Substantive response of the Local Highway Authority to a planning consultation received under The Development Management Order.

Planning Application Number: 24/01061/OUT

Application Address: Land North Of Barlestone Road Newbold Verdon Leicestershire

Description of Application: Outline planning application (all matters reserved except vehicular access) for the erection of up to 240 residential dwellings (Use Class C3), retention of the existing accesses off Barlestone Road and the creation of new accesses off Barlestone Road, land safeguarded for a cemetery and a health centre (Use Class E(e)), public open space and associated infrastructure

Below, the LHA has provided a greyscale extract from the indicative site layout, which illustrates what could be one option.

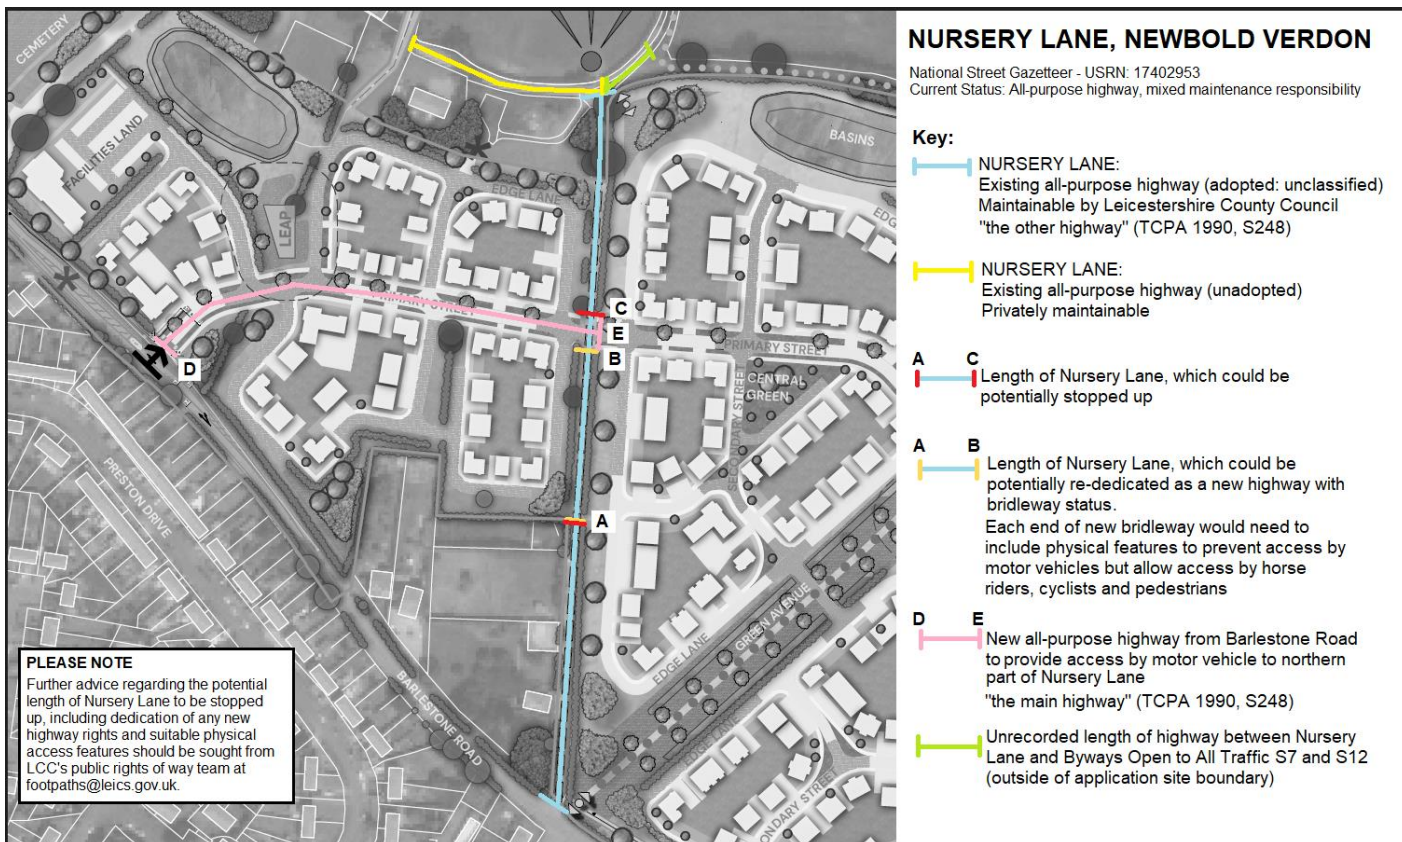
Nursery Lane between Points A and C (“the other highway”) could be stopped up under S248 because it crosses the proposed new highway (“the main highway”). The proposed new highway would preserve access for all forms of traffic from Barlestone Road to the northern part of Nursery Lane via Points D to E, while the unaffected part of Nursery Lane from Barlestone Road to Point A would preserve access for all forms of traffic to existing third-party land.

Between Points A and B, the stopped up length of Nursery Lane could be re-dedicated as a new highway with bridgeway status, enabling the retention of a through route for pedestrians, cyclists, and horse riders. Physical features at Points A and B would be required to prevent access by motor vehicles, while allowing access by other forms of traffic. LCC’s public rights of way team will be best placed to advise further on this – footpaths@leics.gov.uk. Appropriate signage may also be needed at the Barlestone Road access to Nursery Lane to make it clear that the route is not only a dead end (as an existing sign already does), but is a bridgeway only after a certain distance.

- It may be feasible for the whole length of Nursery Lane from Barlestone Road to Point A to be stopped up and re-dedicated as a bridleway, with private vehicular access rights reserved for existing adjoining landowners.
- Potentially the Applicant could close the existing junction of Nursery Lane with Barlestone Road to vehicles and implement a prohibition of driving order, which would require a Traffic Regulation Order (TRO). Landowners/ residents of Nursery Lane would then need to be re-routed through the development roads. The Applicant would be required to cover all costs associated with the TRO. The road would remain adopted in this scenario.

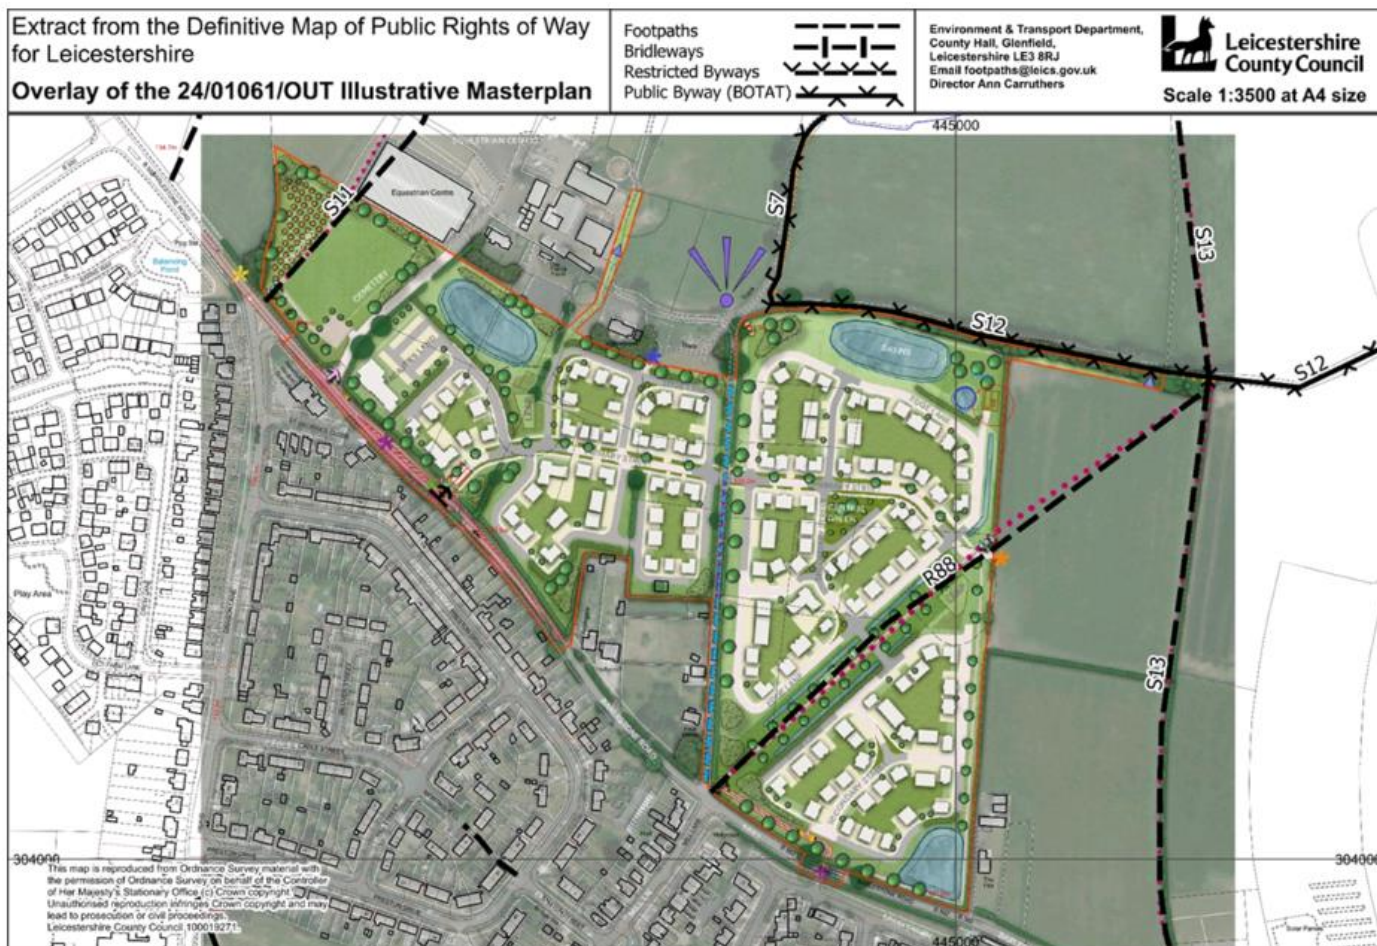
The Definitive Map overlaid onto the Indicative Masterplan dwg no. P22-3085_DE_13_M_01 (see extract overleaf) shows differing routes for Footpath S11 at the northern site boundary, but that reflects a legal diversion in progress after a planning permission at the Equestrian Centre.

However, the masterplan shows Footpath R88 up to 7.5 metres away from its legal alignment. To reconcile this will require a PRoW diversion by a separate legal order made by the LPA, for which a separate application must be submitted and legally confirmed before the development is substantially complete.
